Request for Decision

Application for Rezoning and Plan of Subdivision in order to permit the development of 45 lots for single-detached dwelling units, 63 lots for semi-detached dwelling units, and 2 blocks for medium density residential development, McKinnon Street and Barry Street, Sudbury - 1232252 Ontario Inc

Presented To: Planning Committee

File Number: 751-6/11-13 &
780-6/11004

KEY PLAN
DRAFT PLAN
OF PROPOSED SUBDIVISION OF
PIN 73580-0376
PART OF LOT 1 CONCESSION 4
GEOGRAPHIC TOWNSHIP OF MCKIM
CITY OF GREATER SUDBURY

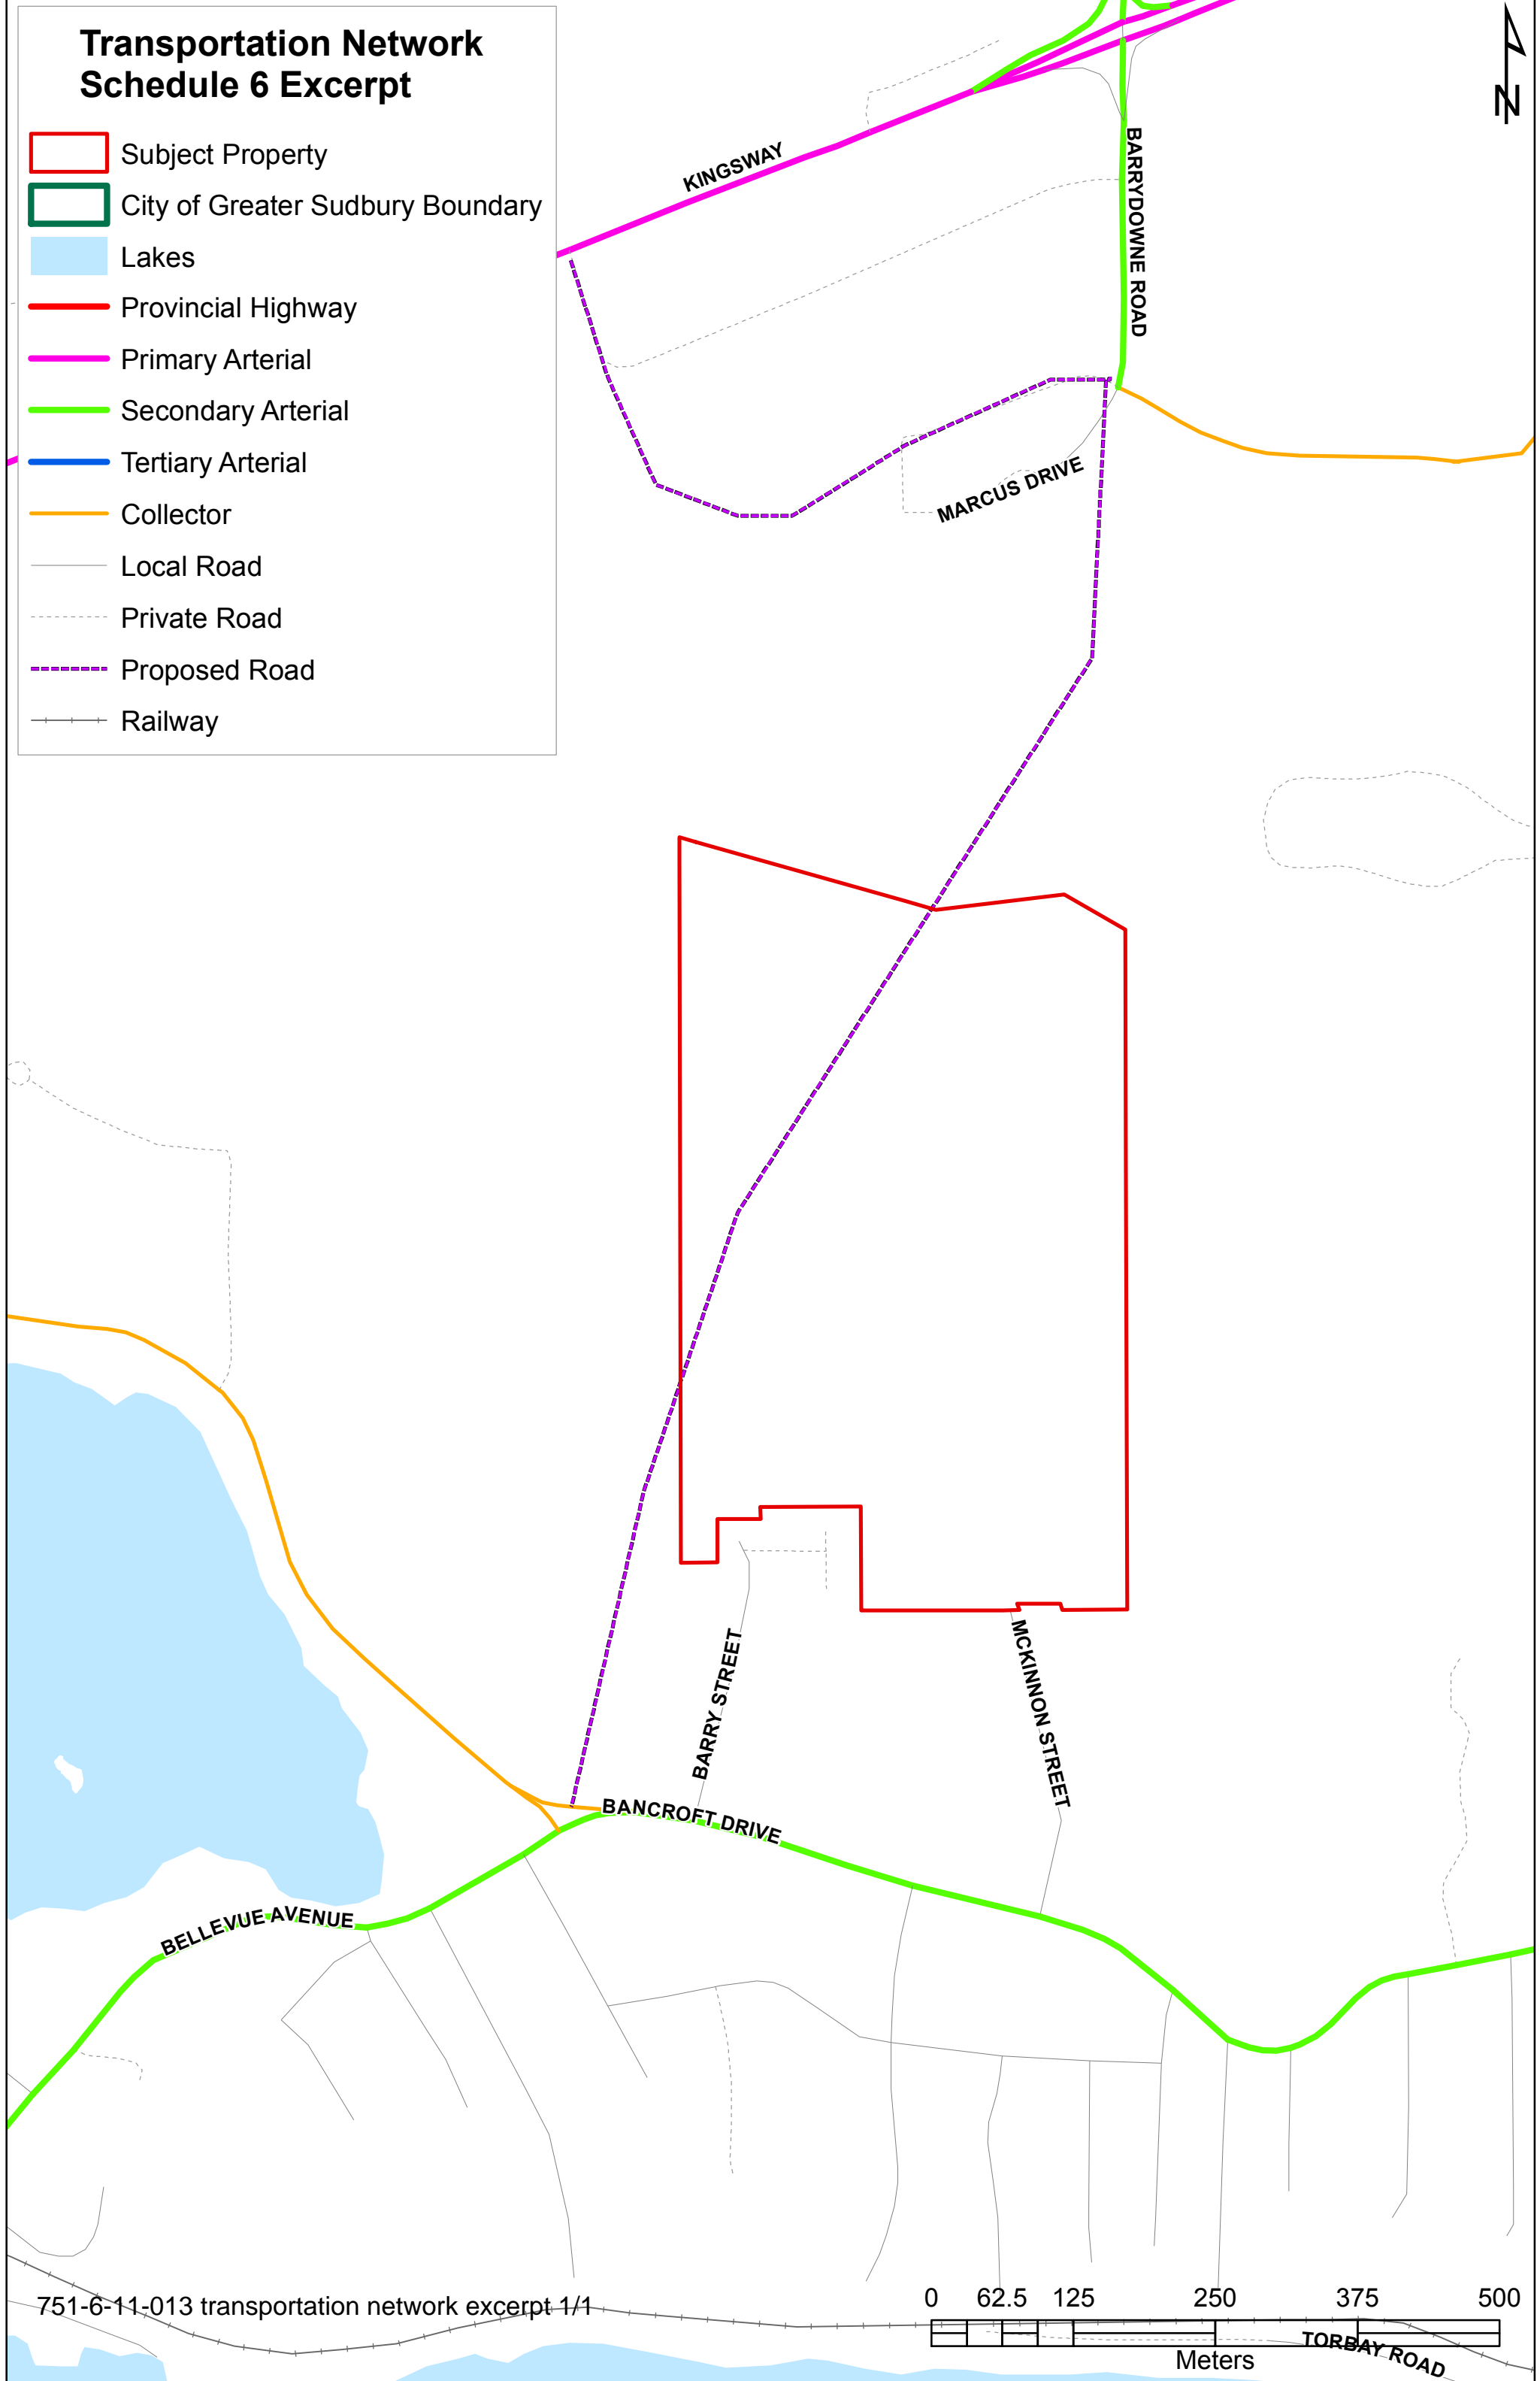
1. That this draft approval applies to the draft plan of subdivision of PIN 73580-0576, Lot 1, Concession 4, Township of McKim, as shown on a plan of subdivision prepared by R.V. Anderson Associates Ltd. and dated August 3, 2011 and redlined as follows:

- a. That the location of Block 111 be finalized in a location and configuration to the satisfaction of the Directors of Leisure and Planning Services;

- b. That Block 112 be revised to include a separate park block in a location and configuration that is to the satisfaction of Directors of Leisure and Planning Services; and,

- c. That Block 113 be revised to include the portion of the walking trail which is currently shown on Block 112 to the satisfaction of the Directors of Leisure and Planning Services; and,

- d. That Block 114 be revised to include a separate block for the portion of the walking trail which is currently shown at the south end of Block 114 to the satisfaction of the Directors of Leisure and Planning Services.
